Wisconsin Department of Transportation

Proposal #35: 9202-08-80, WISC 2014 200
De Pere - Suamico
Wis 29 Relocation US 41 – CTH J
Off Sys
Brown County
Elmhurst Avenue Extension

This is Addendum No. 1, which provides for the following:

ADDENDUM NO. 1

PROJECT NO: 9202-08-80	HWY: USH 41	COUNTY: BROWN	UTILITY DETAILS	SHEET 24A	E

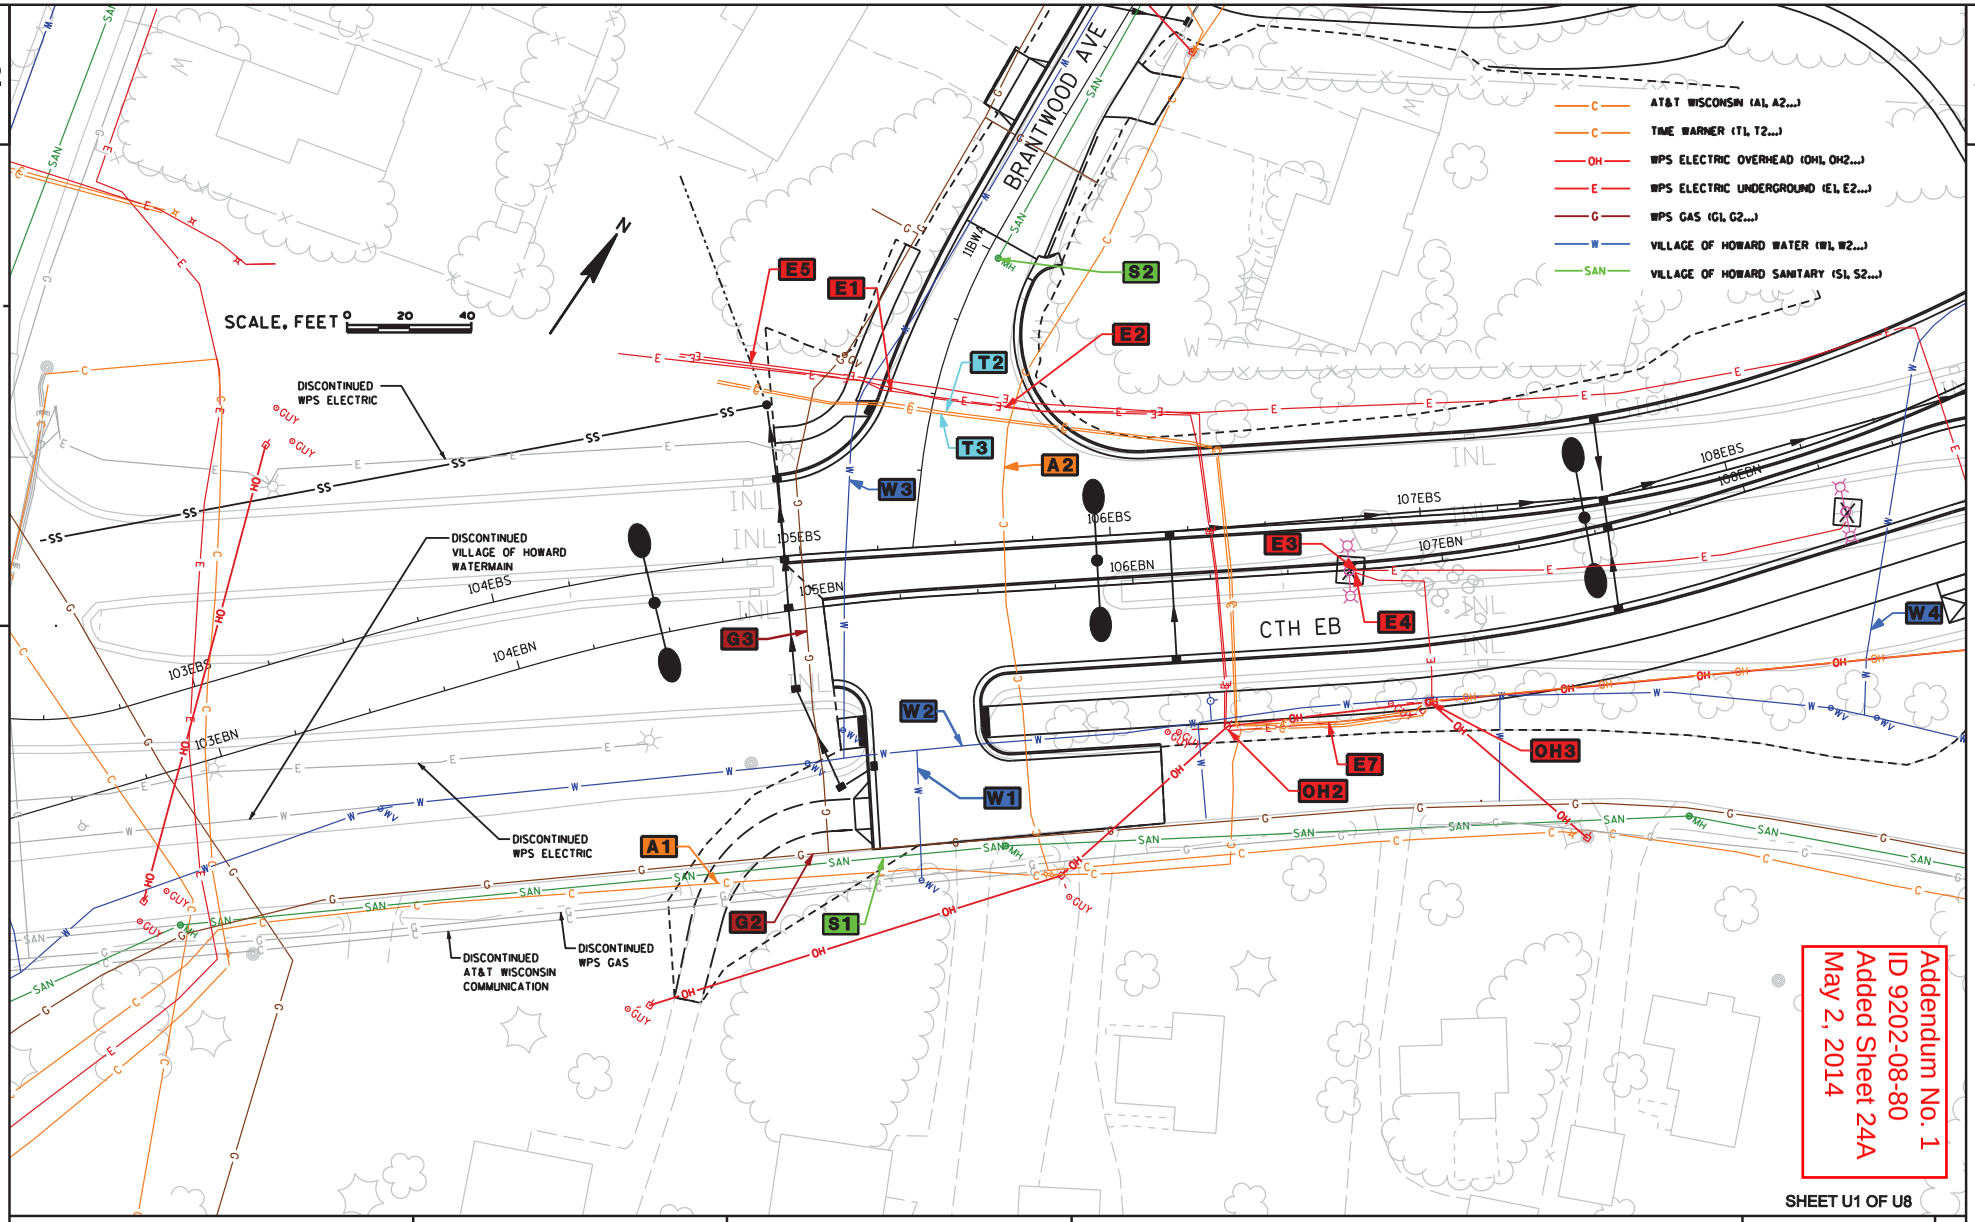
Added Plan Sheets	
Plan Sheet	Plan Sheet Title (brief description of why sheet was added)
24A	Utility Details (Added Every Day Counts sheets)
24B	Utility Details (Added Every Day Counts sheets)
24C	Utility Details (Added Every Day Counts sheets)
24D	Utility Details (Added Every Day Counts sheets)
24E	Utility Matrix (Added Every Day Counts sheets)
24F	Utility Matrix (Added Every Day Counts sheets)
24G	Utility Matrix (Added Every Day Counts sheets)
24H	Utility Matrix (Added Every Day Counts sheets)
62A	Plant Layout Enlargement - Bed 7 (Added Bed 7)

PROJECT NO: 9202-08-80	HWY: STH 29	COUNTY: BROWN	STORM SEWER PLAN AND PROFILE	SHEET 45	E

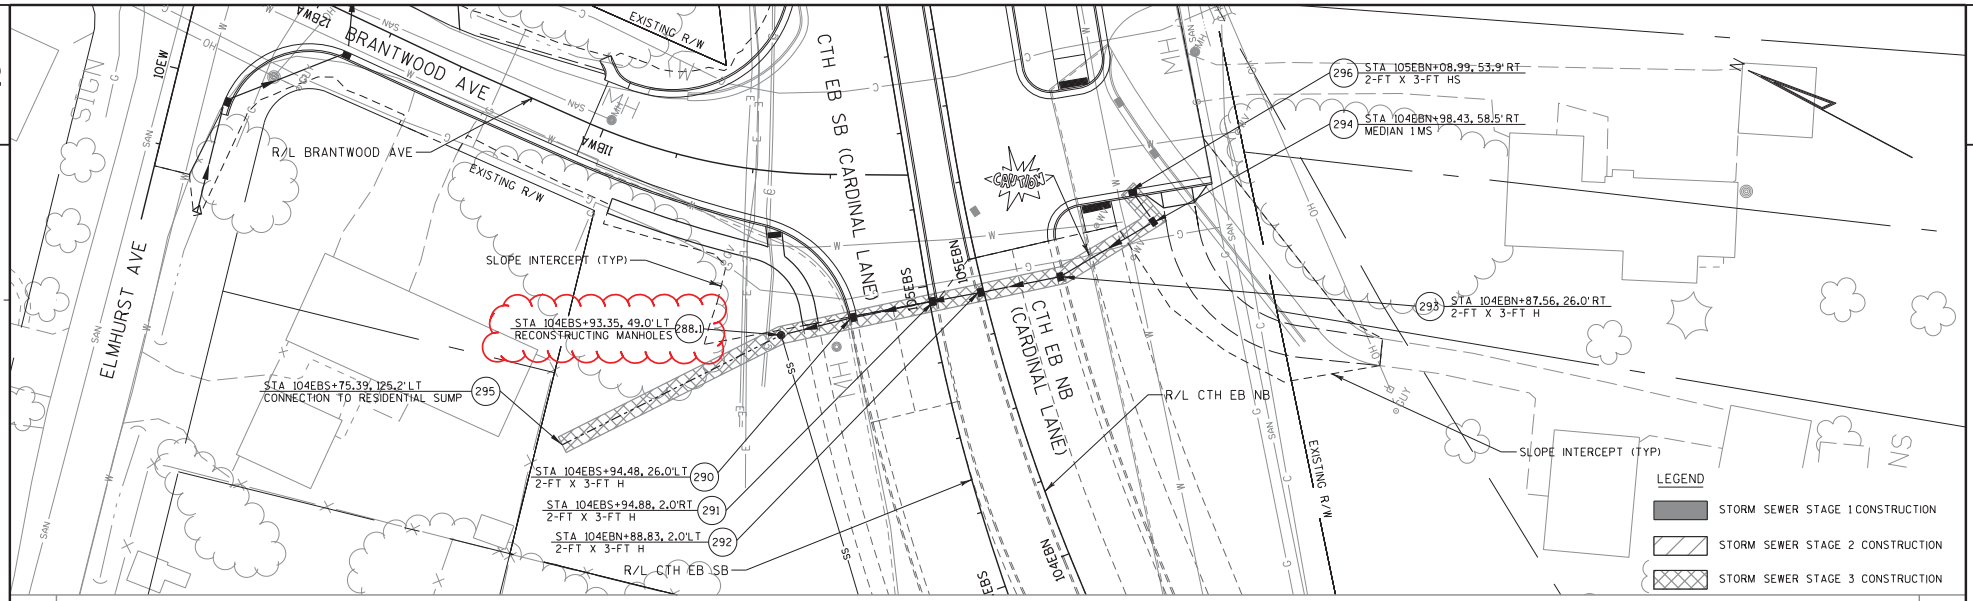
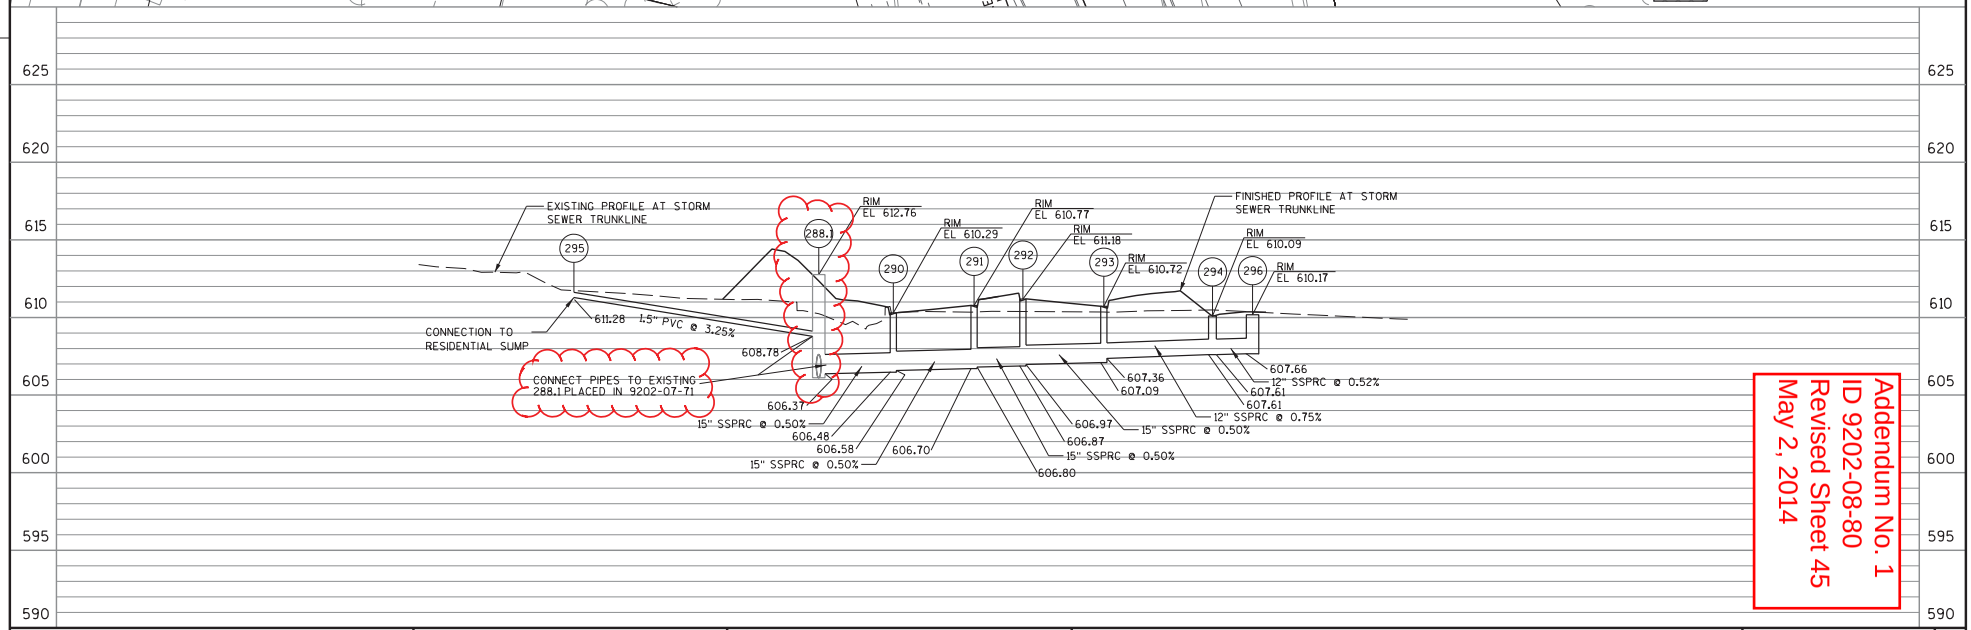
Revised Plan Sheets	
Plan Sheet	Plan Sheet Title (brief description of changes to sheet)
45	Storm Sewer Plan and Profile (Revised 288.1)
53	Plant Layout - Overview (Added Bed 7 area; Revised sheet number)
54	Plant Layout (Revised sheet number)
55	Plant Layout (Added Bed 7 area; Revised sheet number)
56	Plant Layout (Added Bed 7 area; Revised sheet number)
57	Plant Layout Enlargement - Bed 1 (Revised sheet number)
58	Plant Layout Enlargement - Bed 2 (Revised sheet number)
59	Plant Layout Enlargement - Bed 3 (Revised sheet number)
60	Plant Layout Enlargement - Bed 4 (Revised sheet number)
61	Plant Layout Enlargement - Bed 5 (Revised sheet number)
62	Plant Layout Enlargement - Bed 6 (Revised sheet number)
63	Plant Data (Added Bed 7 area; Revised sheet number)
64	Plant Quantities (Added Bed 7 area; Revised sheet number)
65	Planting Details (Added Bed 7 area; Revised sheet number)
66	Stationing (Revised sheet number)
